UNITED STATES PATENT AND TRADEMARK OFFICE

APPLICATION NO.	FILING DATE	FIRST NAMED INVENTOR	ATTORNEY DOCKET NO.	CONFIRMATION NO.
10/673,320	09/30/2003	Nobuaki Miyake	027260-676	2264
21839	7590	07/03/2006		
BUCHANAN INGERSOLL PC (INCLUDING BURNS, DOANE, SWECKER & MATHIS) POST OFFICE BOX 1404 ALEXANDRIA, VA 22313-1404			EXAMINER CAZAN, LIVIUS RADU	
			ART UNIT 3729	PAPER NUMBER

Office Action Summary

DETAILED ACTION

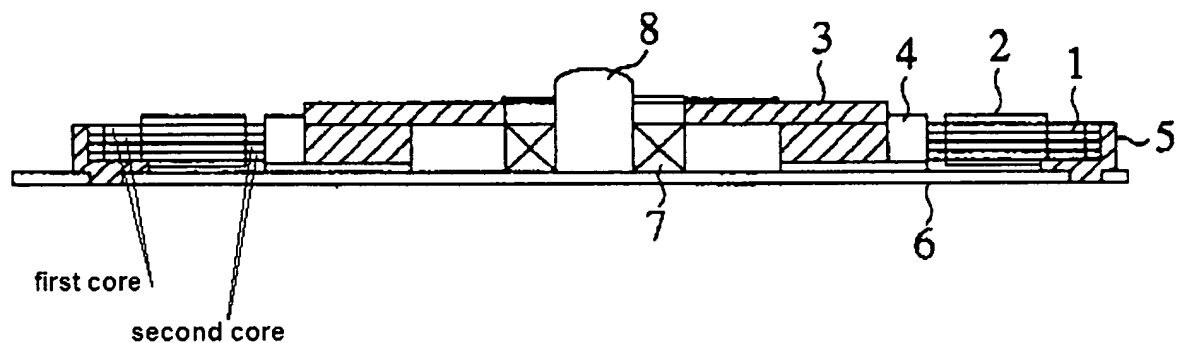
- forming a stacked stator (20 in Fig. 6) core including
 - a plurality of stator cores (a first and second core, see image below; also see Fig. 2), each of which is made up of a prescribed number of stacked sheet magnetic materials (the first core comprises the

top half of the stack of laminated sheets; the second core comprises the bottom half)

- a plurality of yoke members forming each stator core (see the seven yoke members, each having three teeth, Fig. 6)
 - a bendable bent portion provided between said yoke members (see thin portions 10 in Fig. 6)

- an interconnecting portion for interconnecting the plurality of stator cores by connecting the upper end of one stator core to the lower end of another stator core with a difference in level being provided between the plurality of stator cores; the region between the first core and the second core, such that the top of the second core is connected to the bottom of the first core, and a difference in level exists, since the first core is above the second core
